Technical Review Committee

**CITY OF DELAND
THURSDAY MARCH 20, 2025 AT 1:30 P.M.
CITY OF DELAND TRC MEETING ROOM
DELAND, FLORIDA**

City of DeLand
SP24-198
DUPONT
WAREHOUSE

City of DeLand
SP25-007
HULLEY TOWER,
STETSON

City of DeLand
CSB24-001
RESERVE AT VICTORIA
PHASE 4

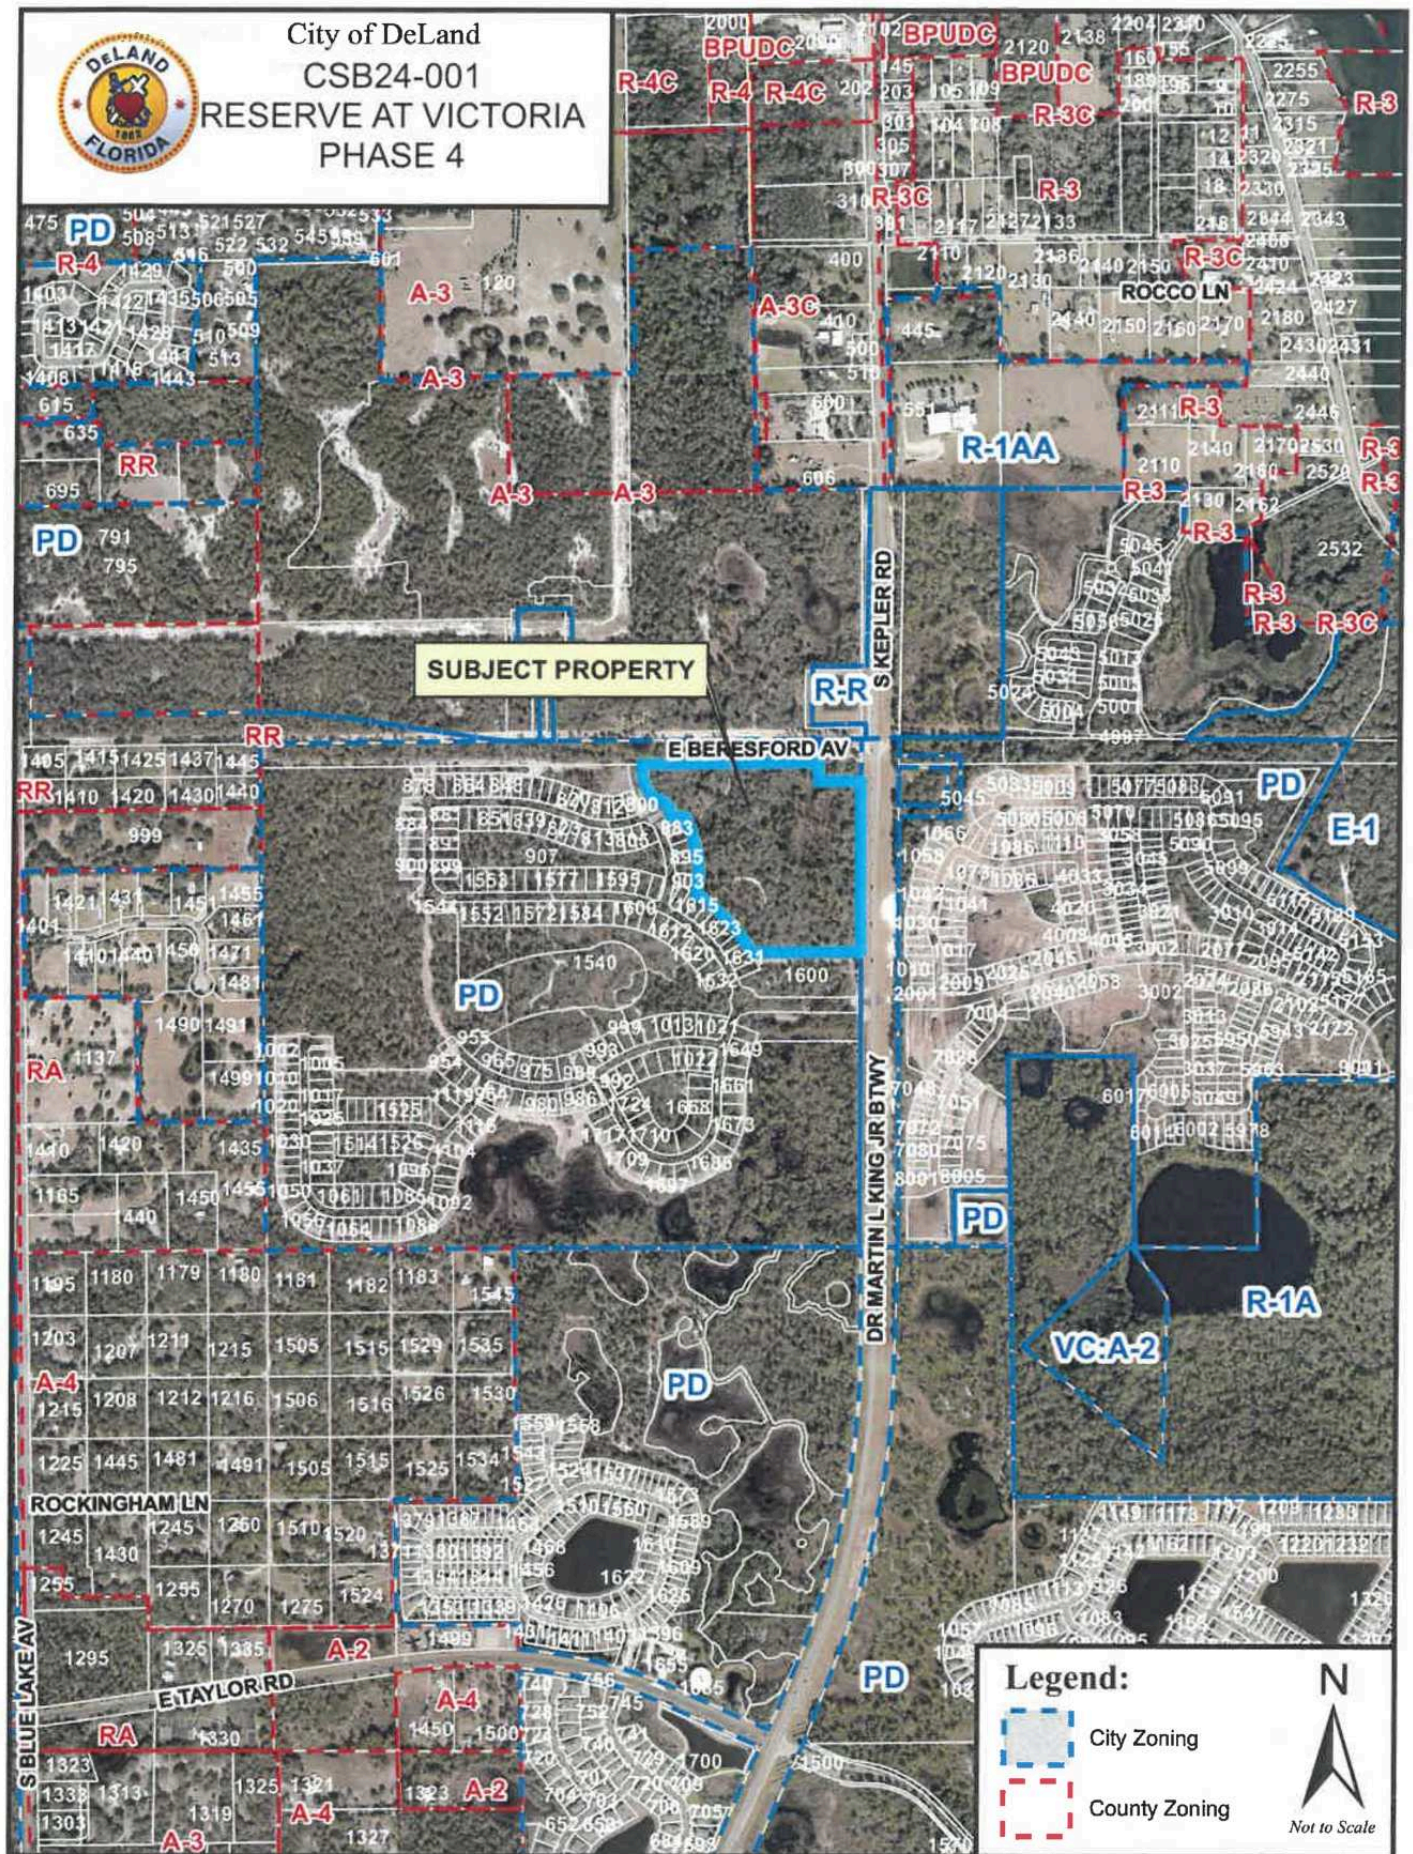
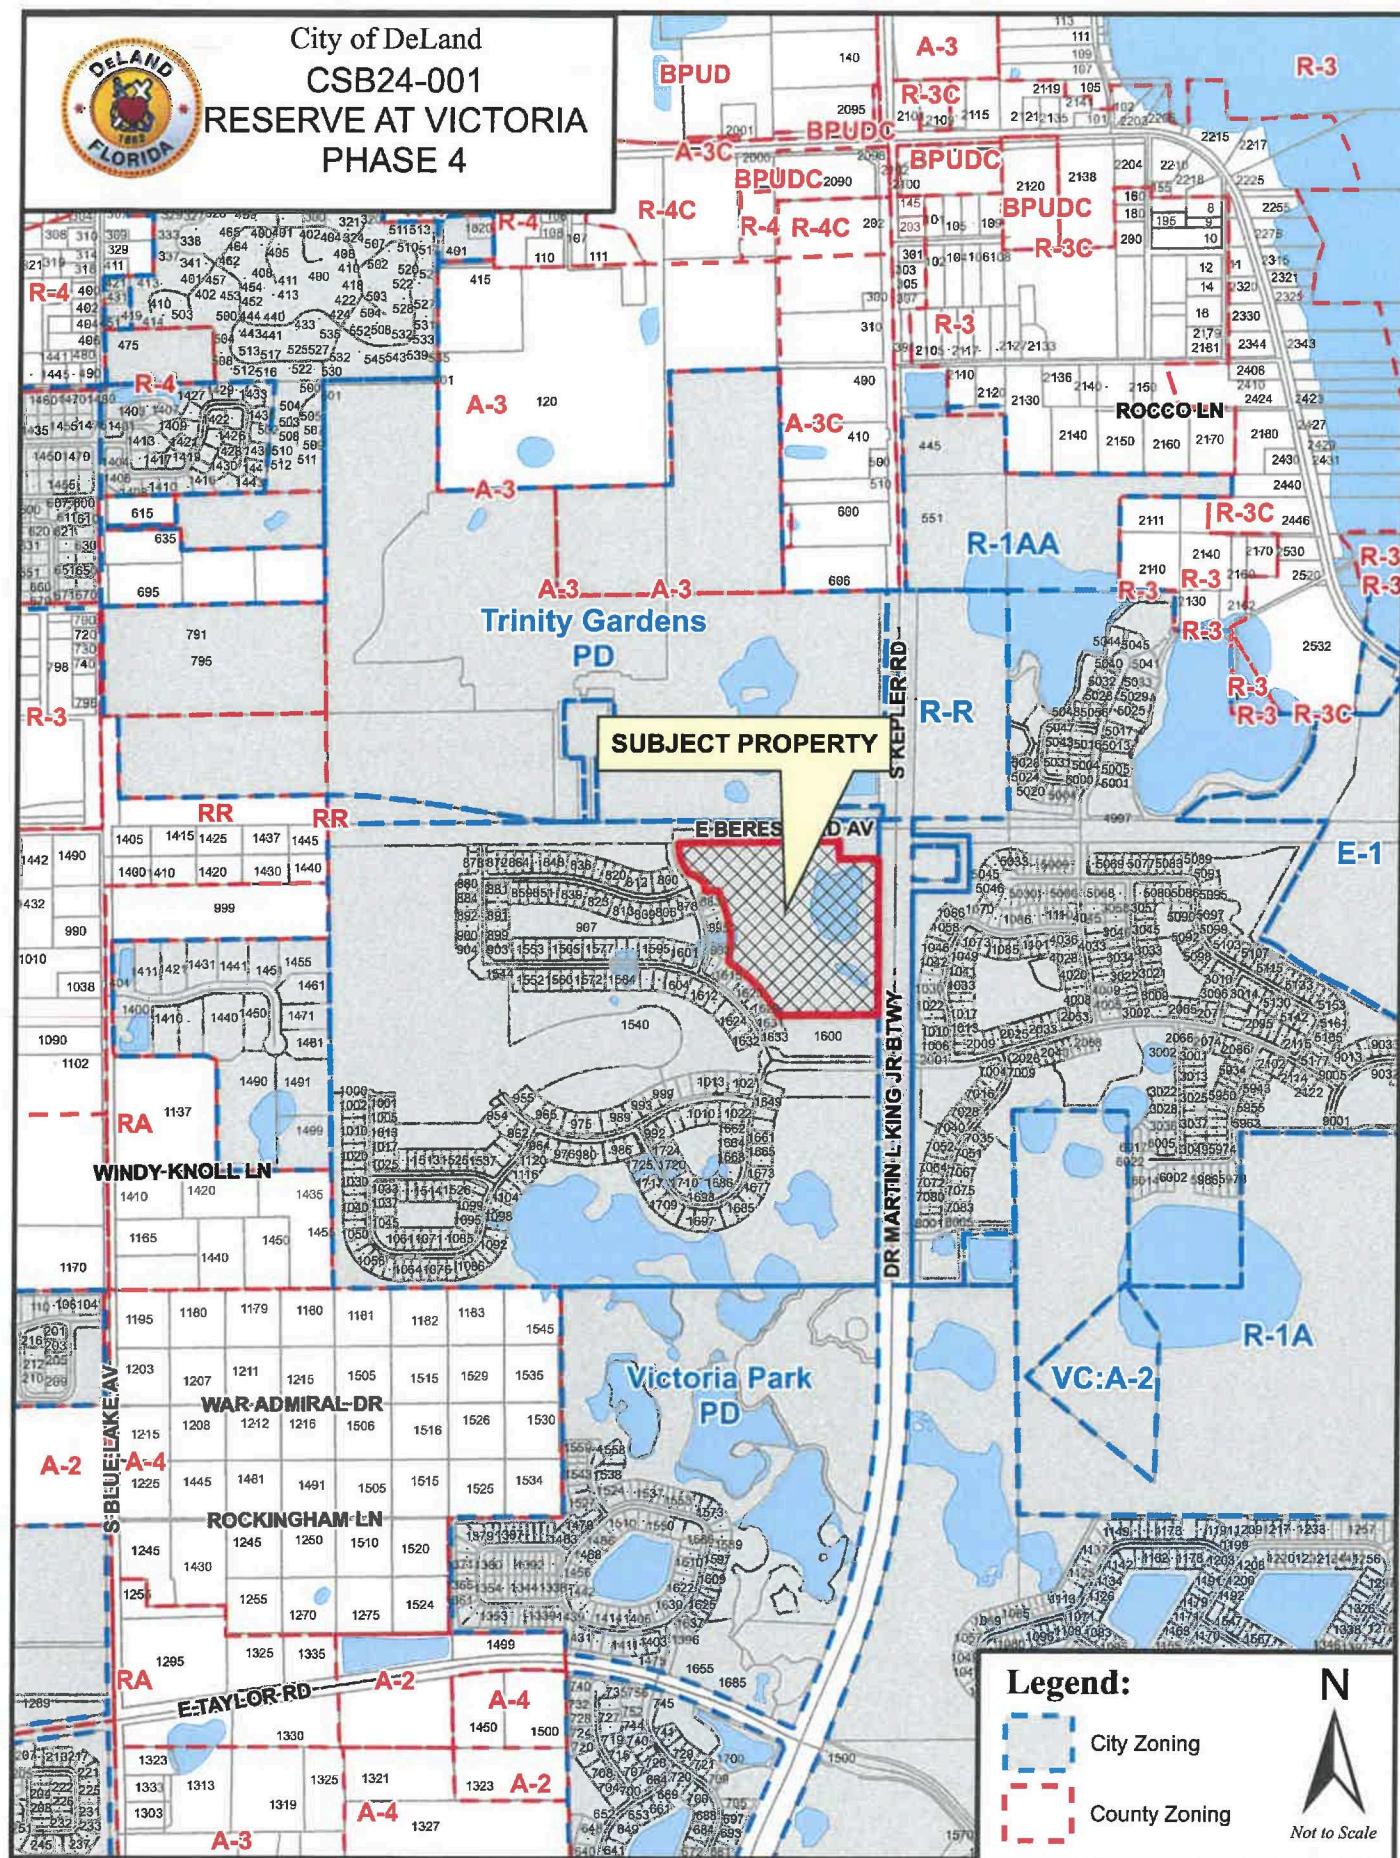
Discipline	Status	Details	Attached To	Created By	Last Updated By	Modifications Required
Engineering	Draft	Maps The Maps included in appendix A indicate Phase 2, not Phase 4.	Stormwater Report_Victoria Phase 4.pdf	Steven Danskine	Steven Danskine	Yes
Engineering	Draft	Maximum Slopes Sections G, H, and I all indicate back slopes of 3:1 (H:V). The maximum slope allowed is 4:1. As these areas are within Natural Buffers, etc., a discussion at TRC regarding possible remedies may be necessary.	24	Steven Danskine	Steven Danskine	Yes
Engineering	Draft	Stormwater 1. In a previous phase, pipe slopes were shallowed up and MES invert elevations in wet ponds were elevated to provide for easier maintenance. Does this want to be taken into account for this phase? 2. Without the benefit of grid lines on the cross section, it appears that elevations on the north side which would otherwise approximate the corresponding elevation on the south side, are lower. Please review for accuracy.	23	Steven Danskine	Steven Danskine	Yes

Engineering	Draft	Storm Structures All storm structures containing risers shall have ram-nek or other suitable joint sealer installed.	04	Steven Danskine	Steven Danskine	Yes
Engineering	Draft	Storm Structures 1. The storm pipe connecting I-15 and I-16 is indicated to be 15" on the structure table, however in the plan view it appears to be identified as 18STM. Please review for consistency as appropriate. 2. Mitered End Sections in ponds at or above normal water levels shall have protection to discourage entrance by children and animals. Please verify for appropriateness. 3. Structure I-24 is identified to be a Type C Inlet which has a short side interior dimension of 2.0' yet 30" diameter pipes are identified to be installed. Please review for appropriateness.	18	Steven Danskine	Steven Danskine	Yes
Engineering	Draft	HOA Reference There are various references to Denison Ridge Homeowners Association, inc. Please review for accuracy.	PLAT SHEET 1	Steven Danskine	Steven Danskine	Yes

Discipline	Status	Details	Attached To	Created By	Last Updated By	Modifications Required
Engineering	Draft	Video Inspection All gravity sewer and stormwater piping shall be video inspected and submitted to the City for review and approval prior to acceptance of the infrastructure.	05	Steven Danskine	Steven Danskine	Yes
Forestry	Draft	Front Yard Trees Please ensure that your landscaping plan provides one front yard tree every 75 linear feet of street frontage. These trees need to be placed between 5' and 15' in from the right of way, and should be shown on the plan.	L1	Kit Dennis	Kit Dennis	Yes
Forestry	Draft	Biome Protected Trees to Remain Natural Total (B) According to the information in the table on sheet 56, only 152" DBH of trees are to remain natural. How are you calculating 341" DBH?	55	Kit Dennis	Kit Dennis	Yes
Forestry	Draft	Specimen Trees to be Removed You are showing 1733" DBH of specimen removals. I am getting 314" DBH when I add the DBH's provided in the table. How are you coming up with 1733"?	55	Kit Dennis	Kit Dennis	Yes

Forestry	Draft	Provided Tree Coverage Your current Plant Schedule provides 36" DBH of palms, 226" DBH shade trees, and 290" DBH understory trees. The total provided is currently 552" DBH. This number will change once you provide a table for the lot trees. The related information provided on this sheet will need to be corrected.	55	Kit Dennis	Kit Dennis	Yes
Forestry	Draft	Tree Barricade Detail Please update the Tree Barricade Detail with the latest version dated January 11, 2024. It can be found on our website.	53	Kit Dennis	Kit Dennis	Yes
Forestry	Draft	Indian Hawthorn and Oleander Indian Hawthorn and Oleander are not on our list of approved replacement trees and will not be counted towards mitigation or minimum coverage requirements. They are both listed as shrubs in the City's List of Permitted Shrubs and Trees.	L1	Kit Dennis	Kit Dennis	Yes
Forestry	Draft	Loguot Add the caliper and height to the specifications. 3" caliper, 8' height.	L1	Kit Dennis	Kit Dennis	Yes

Forestry	Draft	Laurel Oak Laurel Oak is not on our approved list of replacement trees and will not be counted towards mitigation or minimum coverage requirements.	L1	Kit Dennis	Kit Dennis	Yes
Forestry	Draft	Palm Selections Mediterranean Fan Palm, Date Palm, and Queen Palm are not on our list of approved replacement trees and will not be counted towards mitigation or minimum coverage requirements.	L1	Kit Dennis	Kit Dennis	Yes
Forestry	Draft	Site Clearing and Grading Construction Notes -Note 2 should reference the tree barricade detail. -Note 5 should state that silt fence shall be installed in addition to tree barricades. Using	04	Kit Dennis	Kit Dennis	Yes

Discipline	Status	Details	Attached To	Created By	Last Updated By	Modifications Required
silt fence in lieu of tree barricades is not a practice that is encouraged, nor accepted, by the City.						
Forestry	Draft	Erosion Control and Demolition Construction Notes #3 Add "and tree barricades" between the words "devices" and "have".	04	Kit Dennis	Kit Dennis	Yes
Planning	Draft	Dog park Per discussions between the applicant and the city regarding Tract D, it was understood that acceptance of this property and the creation of a dog park would not be undertaken for this project. Explain why it is included in the submittal.	PLAT SHEET 4	Belinda Collins	Belinda Collins	Yes
Planning	Draft	Setbacks Wherever possible, it is recommended to vary the placement of the structures based on the required setbacks to provide variation in the building front placement.	12	Belinda Collins	Belinda Collins	Yes
Planning	Draft	Facade For structures with 75 or less linear feet of building ground floor frontage, fronting on or visible from the public right-of-way, no uninterrupted horizontal length or uninterrupted curve of the building facade shall exceed 35 linear feet, except for architectural facades, which may be allowed to have an uninterrupted length of 60 linear feet. Verify the length of this facade to determine if this requirement applies.	A-6-1	Belinda Collins	Belinda Collins	Yes

Planning	Draft	Street trees There being limited space for front yard landscaping, provide street trees wherever possible to add interest to the area.	3.0A	Belinda Collins	Belinda Collins	Yes
Planning	Draft	Covered front porch areas Verify if the front porch areas include roof structures to provide shelter from the elements when it may be needed.	2.1	Belinda Collins	Belinda Collins	Yes
Planning	Draft	Rear fencing Where appropriate, it may be necessary to provide fencing for some of the townhouse units between or surrounding the patio areas.	2.1	Belinda Collins	Belinda Collins	Yes
Planning	Draft	Building facades Provide renderings demonstrating the use of proposed colors on the buildings. If similar building designs are available to demonstrate a more realistic view of the buildings in a photo format, please provide. Exterior lighting, lighting photometric design, fences and walls, site furnishings, pedestrian access paving and building signage should also be provided.	I.0	Belinda Collins	Belinda Collins	Yes

Planning	Draft	Street trees It is recommended that street trees be placed adjacent to the sidewalks in areas that will break up views to the garage doors and add interest to the streetscape. Because there is only 4 feet of space provided a species such as a Japanese blueberry, single-trunked	L3	Belinda Collins	Belinda Collins	Yes

Planning	Draft		A-6-2	Belinda Collins	Belinda Collins	Yes
Required parking						
Verify that the parking requirements are met based on the following: Resident parking: Studio: 1 space/unit, 1 bedroom: 1.5 spaces/unit, 2, 3, or more bedrooms: 2 spaces/unit, visitor parking: .5 space/unit						
Planning	Draft			Belinda Collins	Belinda Collins	Yes
Trash disposal						
Explain how trash disposal will be handled and where any communal trash facilities are to be located.						
Planning	Draft			Belinda Collins	Belinda Collins	Yes
General information						
Include general information about the acreage and number of lots for the other phases of the development (i.e. Phase 1 = X acres, x# single-family lots etc).						
Planning	Draft		01	Belinda Collins	Belinda Collins	Yes
Dates						
Final plat -- provide date of survey and plat preparation						
Planning	Draft		PLAT SHEET 2	Belinda Collins	Belinda Collins	Yes

Planning	Draft	Biome The Biome Plan indicates 1.38 acres as an area to "Remain Natural", however, this area will be developed as a retention area and therefore not natural. The total should reflect "0". The tree buffer area is to remain undeveloped and could be counted as natural. Include the acreage of that area.	56	Belinda Collins	Belinda Collins	Yes
Planning	Draft	Conservation tracts Tracts B and H are listed as conservation areas. Verify whether or not the 40-foot natural buffers serve as part of the overall TPA and if not what percentage of phase 4 they constitute.	PLAT SHEET 2	Belinda Collins	Belinda Collins	Yes
Planning	Draft	Clearing No clearing of the property is permitted until the final plat is approved. NOTE: A related project, SP24-228, Reserve at Victoria STOCKPILE, has not received final approval. TRC granted conditional approval subject to the comments being addressed. There are still outstanding comments to be addressed.	PLAT SHEET 2	Belinda Collins	Belinda Collins	Yes
